Access Compliance Report Public Rights-of-Way (Curb Ramps)

Main Street: CORPORATE_DR Cross Street: TERRACE_RD Location: SE

ADA ID: RPRK211115161636 Ramp Type: Type 4 - Parallel Initial Pass/Fail: Fail Overall Compliance: No Severity Score: 32

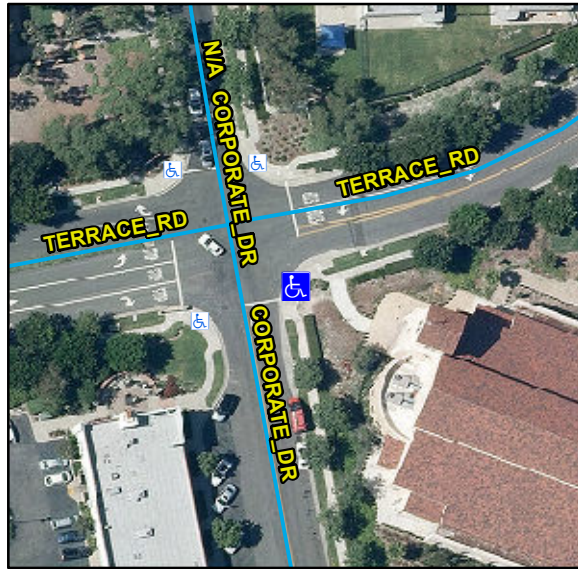
R204.3, R304.3.2, R304.5.3, STD 1115

Compliance	Description	Data	Compliance	Description	Data
N/A	Ramp Length LT (in)	129	N/A	Ramp Length RT (in)	133
Yes	Ramp Width LT (in)	90	Yes	Ramp Width RT (in)	90
No	Ramp Run Slope LT (%)	12.3	Yes	Ramp Run Slope RT (%)	2
Yes	Ramp Cross Slope LT (%)	1.7	No	Ramp Cross Slope RT (%)	2.2
N/A	Landing Present	N/A	N/A	DWS Provided	N/A
N/A	Landing Length (in)	N/A	N/A	DWS Contrast	N/A
N/A	Landing Width (in)	N/A	N/A	DWS Length (in)	N/A
N/A	Landing Run Slope (%)	N/A	N/A	DWS Full Width	N/A
N/A	Landing Cross Slope (%)	N/A		DWS Offset Type	N/A
N/A	Landing Movement Obstructed?	N/A	N/A	DWS Offset Left (in)	N/A
	Landing Movement Type	N/A	N/A	DWS Offset Right (in)	N/A
N/A	Landing Shared	N/A			
N/A	Clear Space	Yes			
N/A	Clear Space To Crosswalk (in)	N/A			
N/A	Marked Crosswalk 1	No	N/A	Marked Crosswalk 2	No
	Crossing 1 Direction	N		Crossing 2 Direction	E
	Marked Crosswalk 1 Width (in)	N/A		Marked Crosswalk 2 Width (in)	N/A

Remove & Replace Curb Ramp With Two New Directional Ramps or Equivalent.
